**Wisconsin Electric** POWER COMPANY  
231 W. MICHIGAN, P.O. BOX 2046, MILWAUKEE, WI 53201

April 28, 1983

DOCKET NOS. 50-266 AND 50-301  
APPENDIX R EXEMPTION REQUESTS  
POINT BEACH NUCLEAR PLANT, UNITS 1 AND 2

FIGURE 4-1

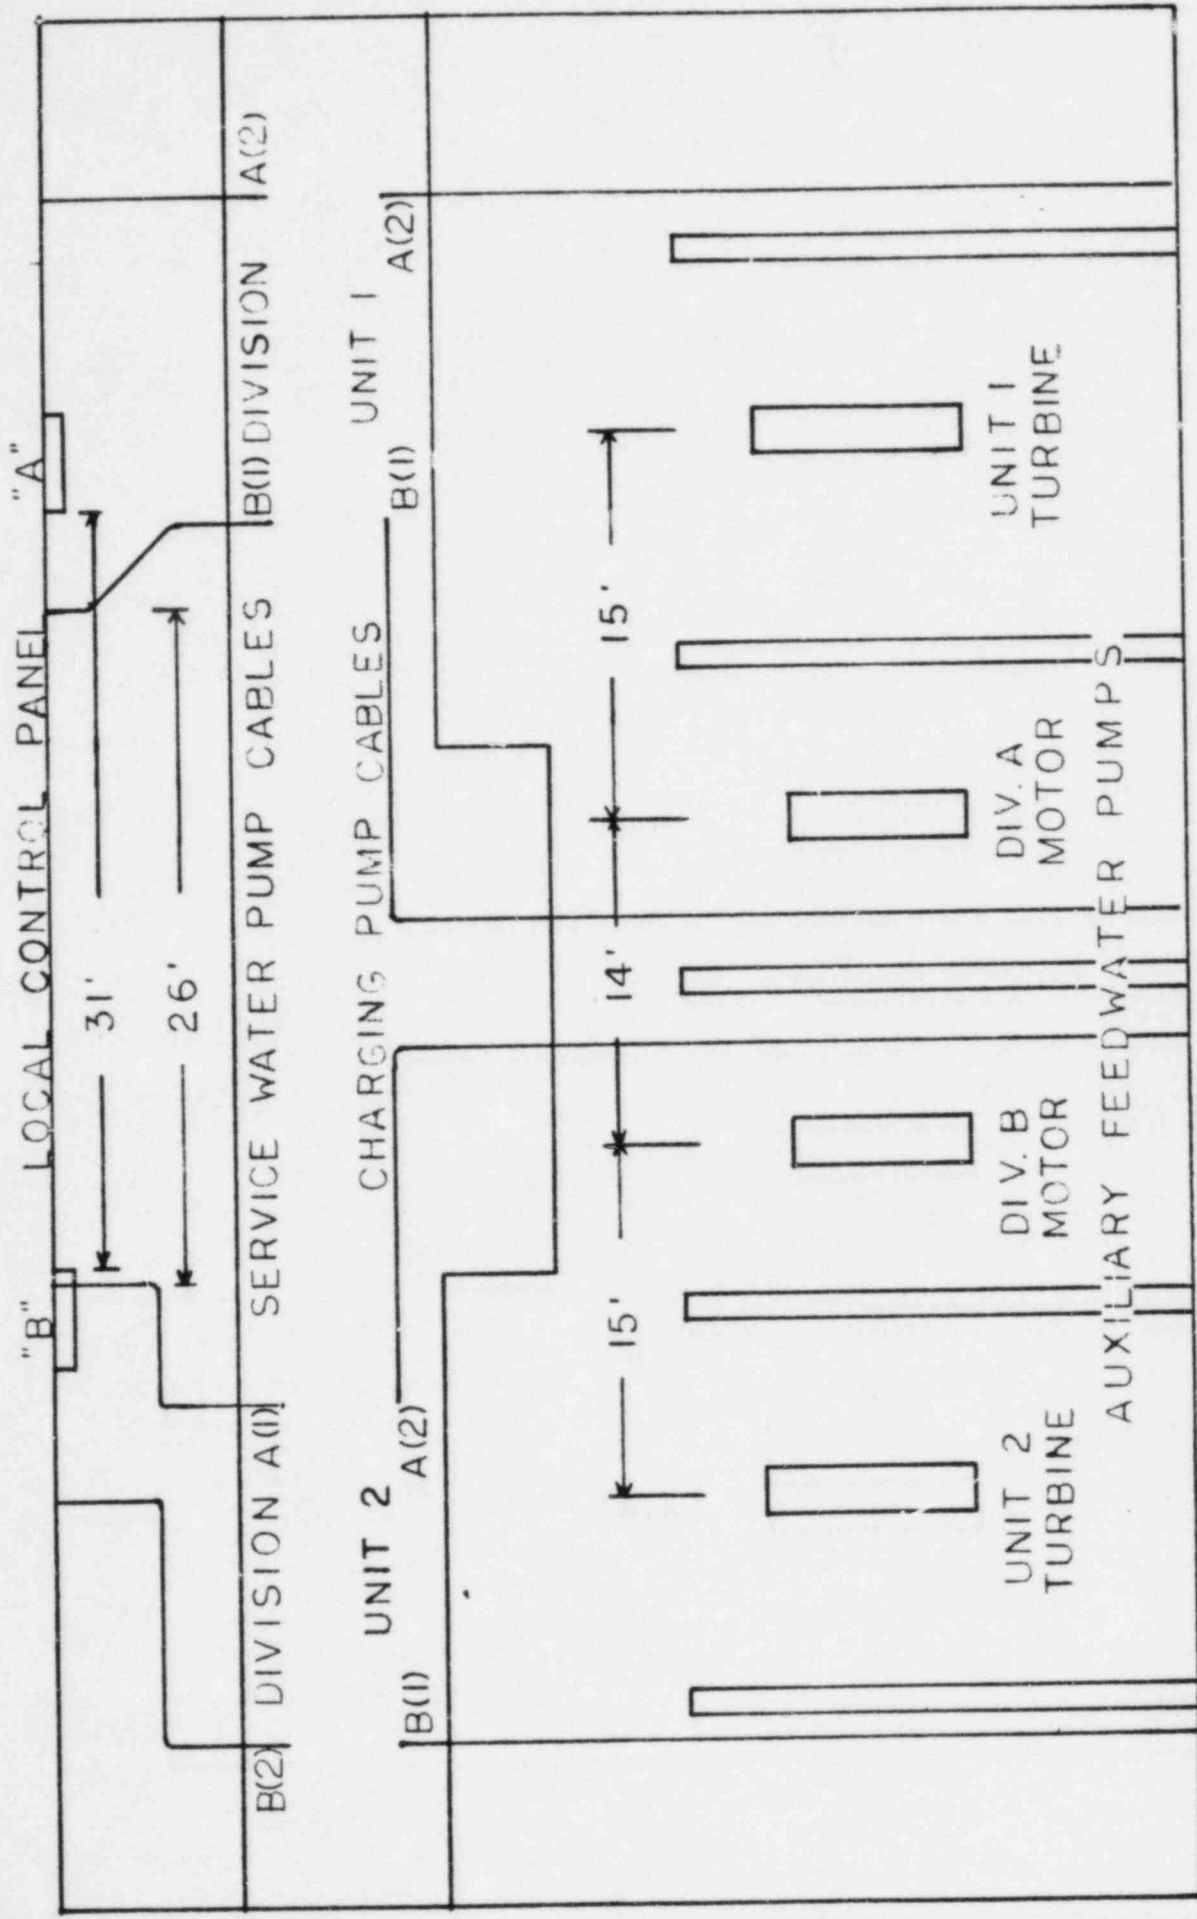
The arrangement of required hot shutdown components is shown on Figure 4-1.

Divisions "A" and "B" local control panels are located on the east wall of Fire Area 5 at a height of approximately 5 feet. The lowest cable tray at the east wall is located at a height of 8'-6". All cable trays in the area run perpendicular to the east wall and no cable trays traverse the intervening space between the local control panels. The control room is decoupled from affected circuits at the local control panels. These panels are separated by a distance of approximately 31 feet as shown on Figure 4-1. WE considers the existing separation to be satisfactory to Appendix R requirements.

Redundant divisions of CVCS system charging pump power and local control cables for each unit are located in Fire Area 5. The cables penetrate the ceiling to switchgear mounted on the floor above. The separation distance between penetrations is 11 feet. WE has proposed relocation of one division of cables for each unit to provide improved separation. The relocated cables will be IEEE-383 qualified and rerouted in conduit throughout the fire area. The conduits will be routed from the ceiling penetrations to a separation distance of 29 feet for Unit 1 and 27 feet for Unit 2. WE also proposed to wrap the entire length of conduit using a material such as a double wrap of 3M flexible fire barrier material.

FIGURE 4-2  
AUXILIARY FEEDWATER PUMP ROOM

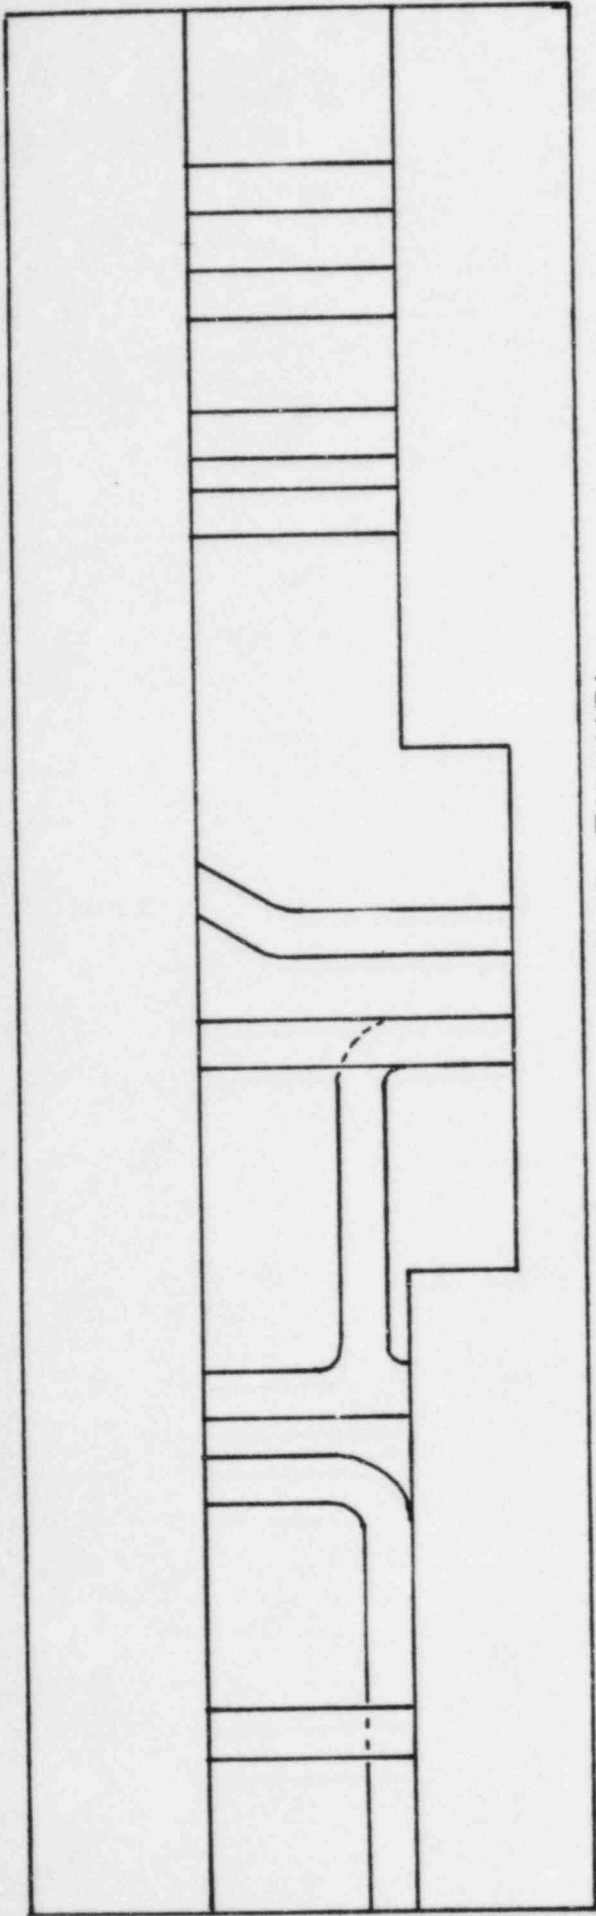
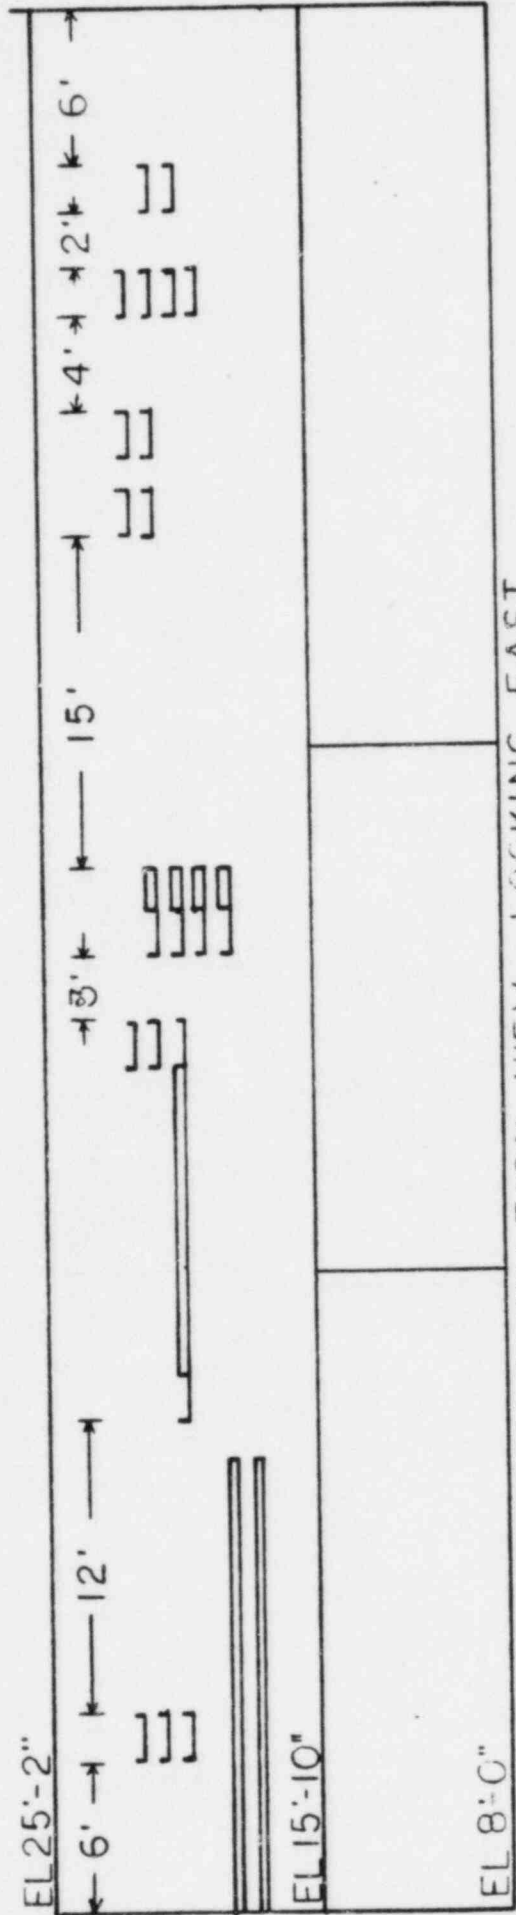
A slide projection visual to describe Fire Area 5 was used at the March 22 meeting. Most views were in the north or south direction, transverse to cable tray routing, in order to show the long unimpeded aisle in front of individual auxiliary feedwater pump bays. Views of redundant safety cable trays were in the same direction which presented a distorted view of intervening cable trays. This implied that access to cable trays above the tunnel for manual fire suppression activity would be severely restricted. Intervening cable trays are generally routed parallel to redundant safety trays. The cable tray arrangement above the tunnel is shown on Figure 4-2. A significant quantity of conduit is routed near the ceiling and along the side of cable trays. This has been omitted from Figure 4-2 for reasons of clarity and would not significantly impede access to the cable trays. Figure 4-2 indicates that generally good access exists to cable trays above the tunnel.

**FIGURE 5-1**  
**DIMENSIONS OF THE 4160 VAC**  
**SWITCHGEAR ROOM**

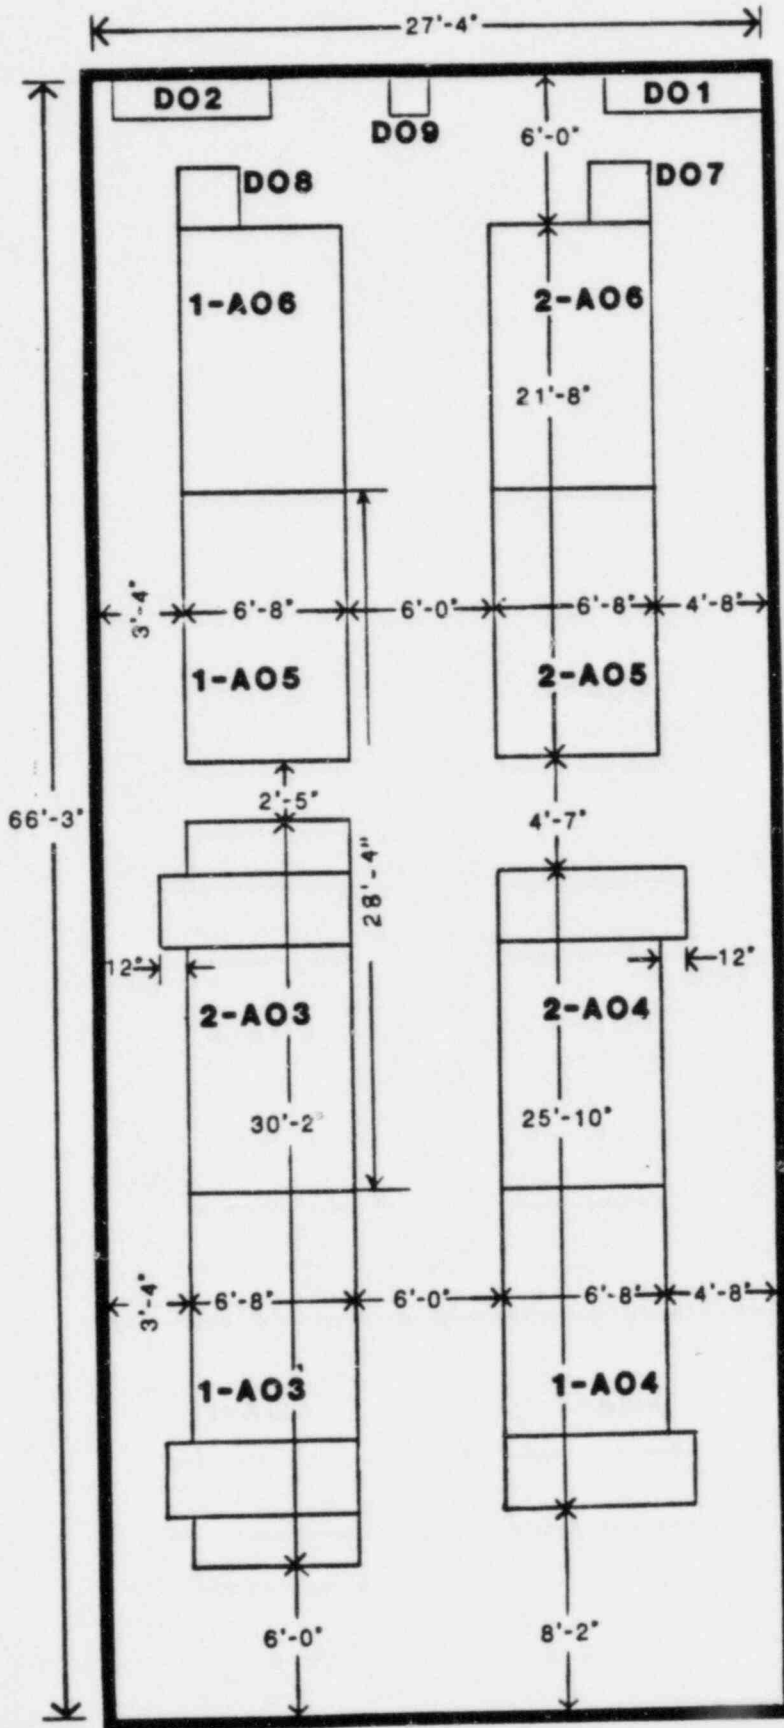
The switchgear configuration within the room is shown on Figure 5-1. Safeguards switchgear A05 and A06 for each unit is located end to end in the north half of the room with a bus tie cabinet between divisions. Each switchgear bus is composed of several individual switchgear cabinets. Circuit connections to the individual cabinets penetrate the cabinet

roof. There are no sidewall penetrations between individual cabinet device sections. Each cabinet has a vertical division wall between the frontal device section and the rear bus bar section. Insulated bus bar connections penetrate the division wall. The cabinet bus bar section sidewalls are slotted to accommodate the solid copper bus bar. The bus bar for one switchgear division is located in the top half of the cabinets and the bus bar for the redundant division is located in the bottom half of the cabinets. The bus bar section of the bus tie cabinet is constructed with one solid sidewall and a solid horizontal division plate to provide bus bar isolation. The device section of the bus tie cabinet is common to both divisions of safeguards switchgear. WE proposes to provide an independent Halon suppression system for this cabinet which will be actuated by smoke detectors located inside the cabinet.

FIGURE 6-1  
CABLE SPREADING ROOM  
DIMENSIONS

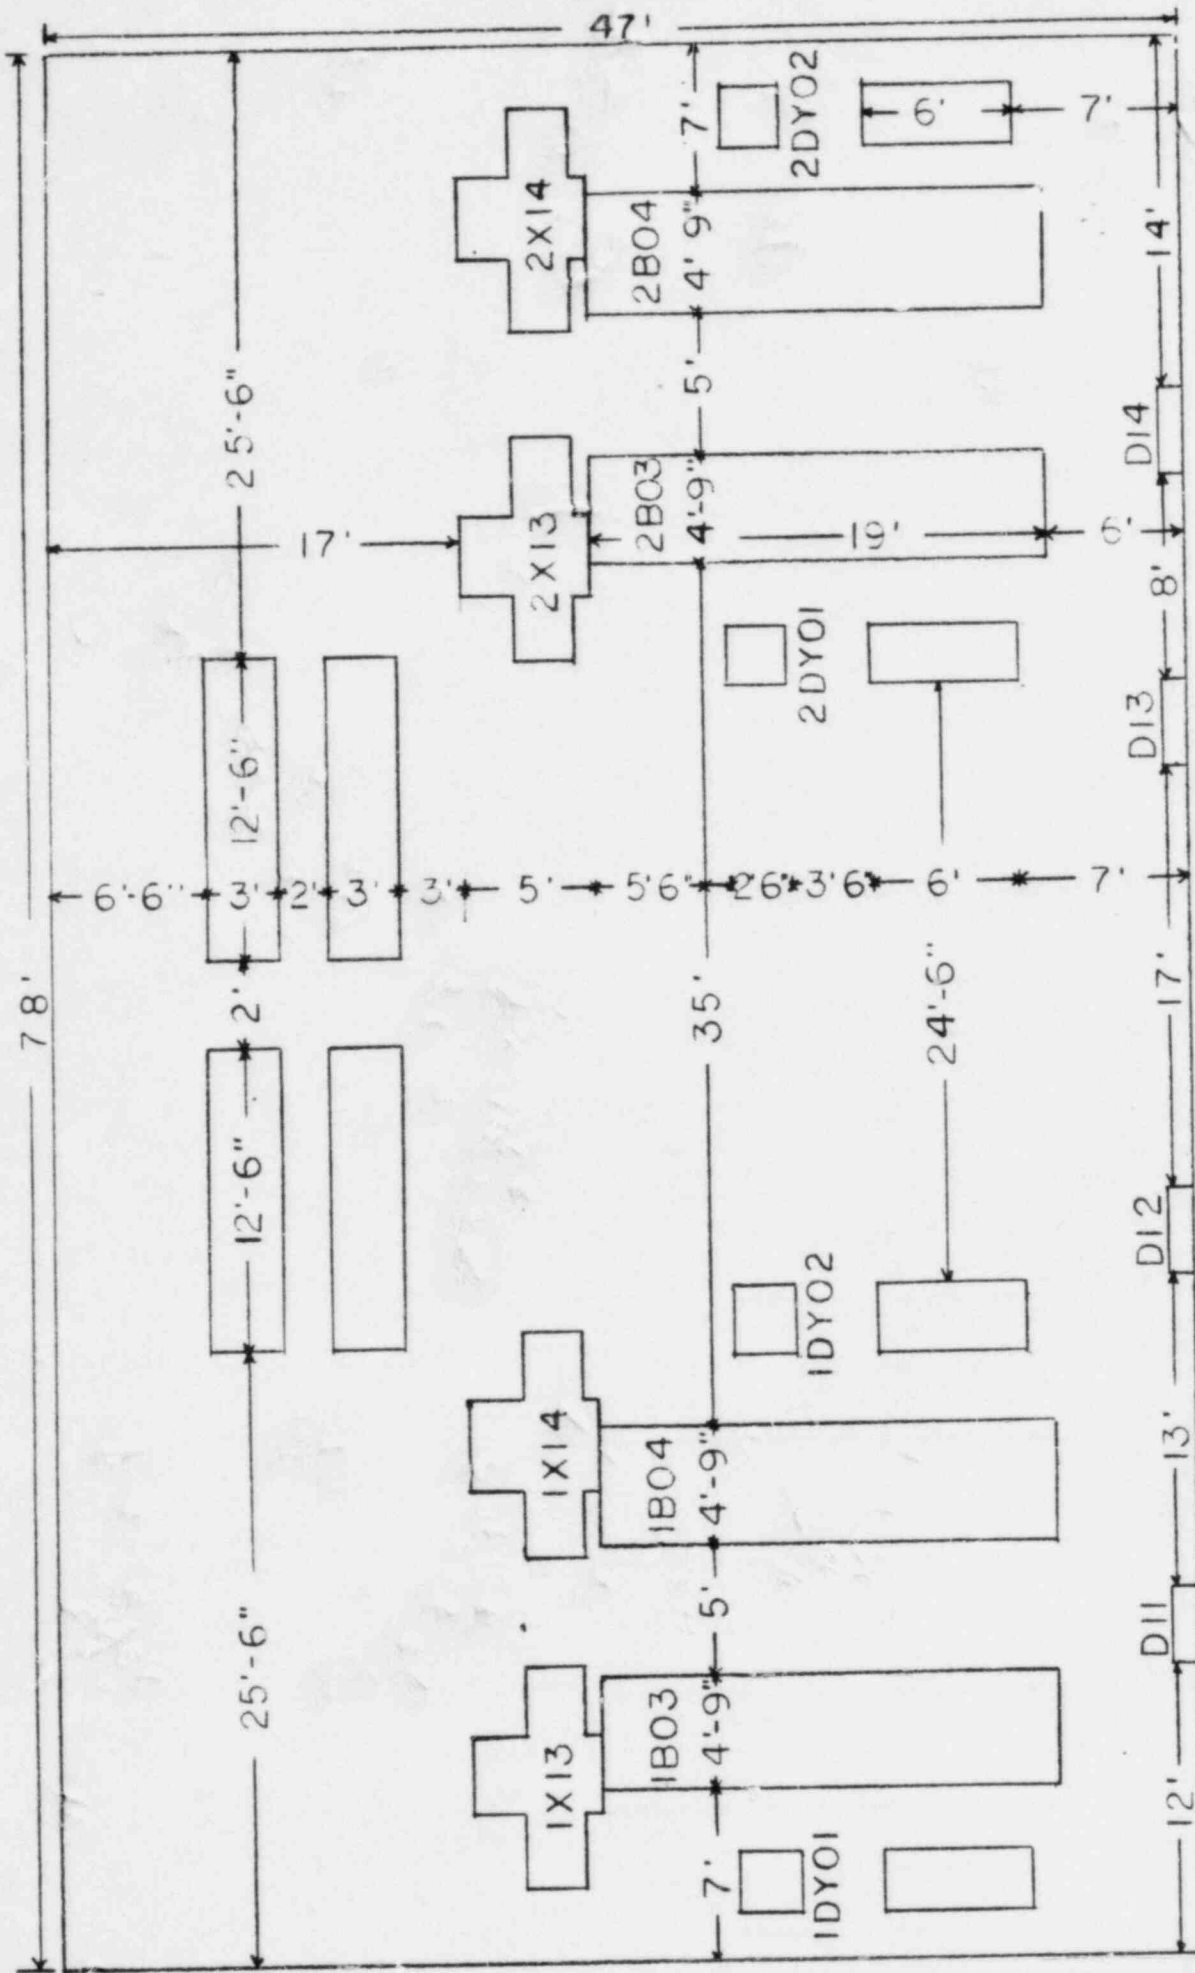
The general arrangement of Fire Area 8 is shown on Figure 6-1. Redundant divisions of 480V switchgear for each unit are located at the north and south ends of the room. Because of the large open room area between the redundant rows of switchgear, it is reasonable to conclude that only limited fire damage will occur and that one redundant set of switchgear will be available to provide the power necessary for hot shutdown. This conclusion is enhanced because of the single failure proof Halon automatic fire suppression system installed in the room. WE has committed to install an additional fire detection system using rate compensating thermal detectors in order to provide redundant actuation for the Halon suppression system.

**FIGURE 6-2**  
**MODIFICATIONS TO THE POWER CIRCUIT**  
**FOR THE CHARGING PUMPS**

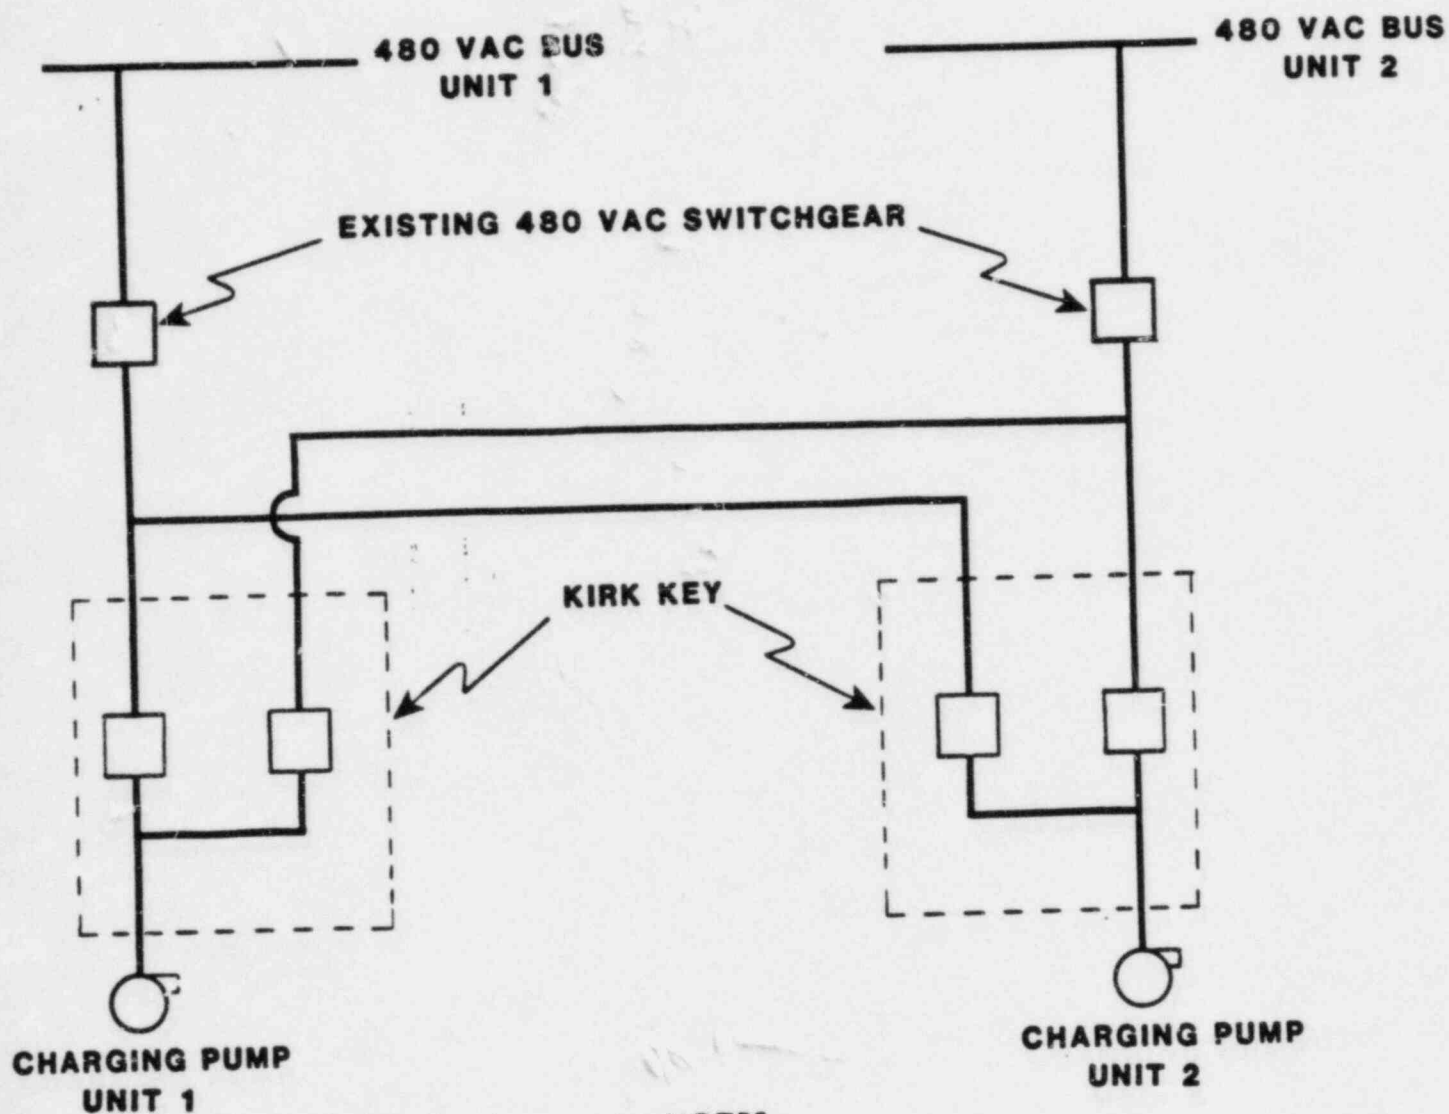
Several safe shutdown systems at Point Beach are plant specific rather than unit specific which means that the redundant division power supplies do not originate at the same set of switchgear. Steam driven auxiliary feedwater pumps are independent of the cable spreading room. The division "A" motor driven pump receives power from the south set of switchgear while the division "B" pump receives power from the north set. Two division "A" and one division "B" service water pumps receive power from the south set of switchgear while one division "A" and two division "B" pumps receive power from the north set. Therefore, sufficient equipment for these systems will be available to achieve hot shutdown. The CVCS charging pumps, however, are unit specific and the loss of a redundant set of switchgear would leave one unit without this required equipment. WE proposes to provide emergency power crosstie capability so that one charging pump for each unit will be available. The modification consists of providing two key-locked breakers for one charging pump of each unit as shown on Figure 6-2. The key-lock feature provides protection against inadvertent paralleling of power supplies via the breaker crosstie. Because of our determination that
